Severe accident mitigation strategy for the generation II PWRs in France – some outcomes of the on-going periodic safety review of the French 1300 MWe PWR series

IRSN / PSN-RES / SAG

Figure 1: reactor cavity passively flooded up to the maximum level available (schematic view)

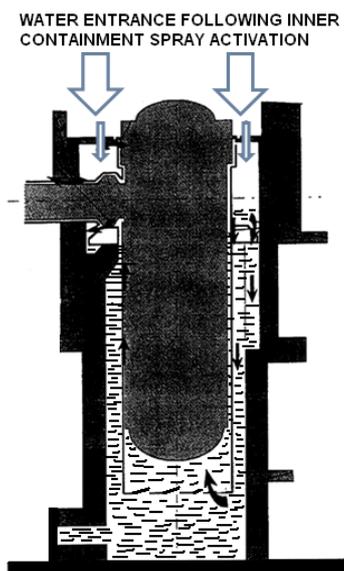
The French 1300 MWe PWRs have a reactor cavity surrounded by horizontal concrete floors (FIG 4). The extremities of these floors do not touch the inner containment wall and EDF performed calculations to know whether or not, under a steam explosion in the reactor cavity, these floors could impact the inner containment wall and endanger the whole containment integrity. After choosing a “realistic” steam explosion pressure loading in the reactor cavity, EDF performed two-dimensional calculations of the reactor cavity walls and containment internal structures mechanical response for a 1300 MWe reactor. The effect of three-dimensional mechanical calculations for such reactor was investigated using the behavior comparison between two and three-dimensional calculations performed on a 900 MWe PWR. As a conclusion, EDF considered the risk associated to a steam explosion in the reactor cavity to be acceptable and the EDF choice for the 3rd ten-yearly outage of the 1300 MWe reactors was to let the reactor cavity be passively flooded up to the maximum level available (RCS pipes level), following inner containment spray activation.

IRSN considers that some conditions must be fulfilled to obtain a sufficiently strong steam explosion in a reactor cavity leading to a loss of containment tightness: for example a large and constraint quantity of water in the reactor cavity and a fragmentation of the jet corium falling in the water after vessel lower head failure. The risk analysis has also to take into account the resistance of the internal structures and equipment in the containment, and the beneficial role of water in the reactor cavity for cooling the corium inside the vessel.

Consequently, in order to reduce as low as reasonably practicable the radiological consequences of a severe accident, IRSN is favourable to severe accident management strategies preventing strong energetic phenomena, such as a steam explosion (at vessel lower head failure). In particular, the reactor cavity should be kept dry until the vessel lower head failure. It eliminates a risk of large early radioactive release and increases the chances to keep fonctionnal the structure, system and components (SSCs) needed for severe accident management after vessel failure (e.g. water injection means) and the chances for corium cooling outside the vessel, in particular due to its spreading on a larger area.

Figure 2: reactor cavity passively flooded up to a relatively low level, thanks to a direct connection between the reactor cavity and the sump (schematic view)

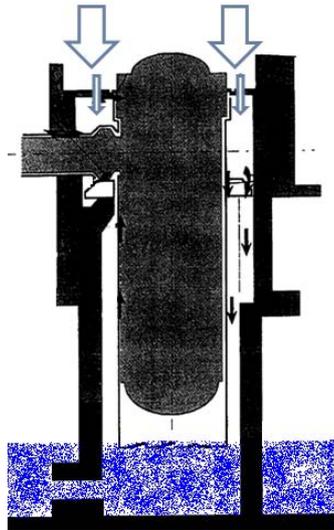
- flooding voluntarily the reactor cavity up to the maximum level available would have required significant equipment modifications not feasible in the time frame of the 3rd PSR,
- controlling the reactor cavity to be passively flooded up to a relatively low level would have a beneficial effect by decreasing strongly the steam explosion consequences, but there is no insurance that a large corium pool can be completely cooled in the reactor cavity,
- maintaining a dry reactor cavity would eliminate the steam explosion risk after vessel lower head failure ; but there is a need for air circulation in the reactor cavity during normal operation (so difficulties to maintain it dry) and there is also no insurance that a large corium pool can be completely cooled in the reactor cavity by a water injection after vessel lower head failure.

Figure 4: schematic view of a French 1300 MWe PWR horizontal floors surrounding the reactor cavity

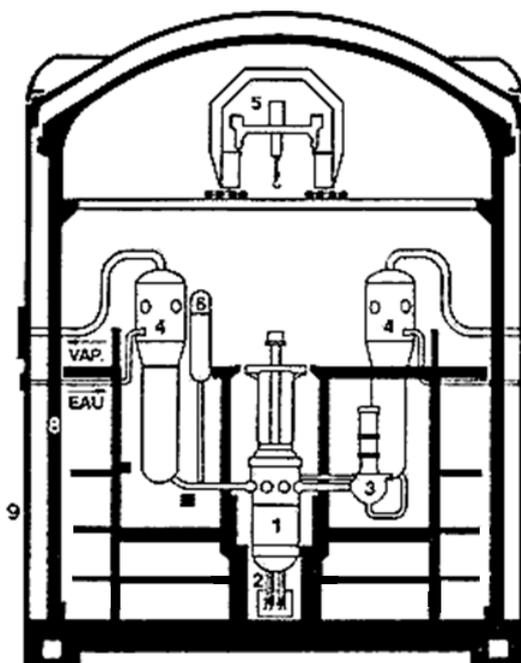
The structure response calculations have shown that the extremities of the horizontal concrete floors surrounding the reactor cavity can move or not up to touch the inner containment wall depending on the 1300 MWe PWR type. They also showed a strong mechanical degradation of the reactor cavity and of the surrounding concrete structures.

- raises questions about potential consequences, for example on heavy equipments (vessel, SGs) and containment penetrations tightness,
- shows a potential for equipment dysfunctions (if not destruction): what is the status of water injection pipes? how to inject water? where is going the injected water if the cavity walls are damaged? could the debris created by the steam explosion lead to sump clogging and consequently to the loss of the inner containment spray under water recirculation mode?

Figure 5: schematic view of the French 1300 MWe PWR EFCVS

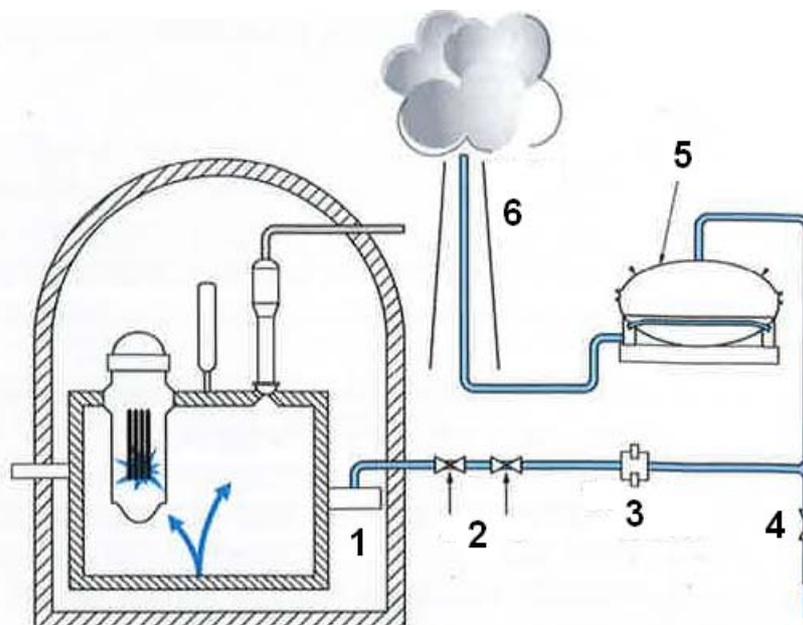
The opening of the EFCVS is manual by means of two isolation manual valves in series, operated locally behind a radiation shield. IRSN noticed that, in other countries, the opening of EFCVs, is either redundant or diversified (manual or motorized valves, rupture disks ...). Consequently, in the framework of the 3rd PSR for 1300 MWe reactors, EDF was asked, by the french advisory group, to perform a feasibility study on the redundancy or diversification of the French EFCVS opening.

It can also be reminded here that, in the framework of long term operation, EDF should improve the efficiency of the present EFCVS to reduce the severe accident radiological consequences [2].
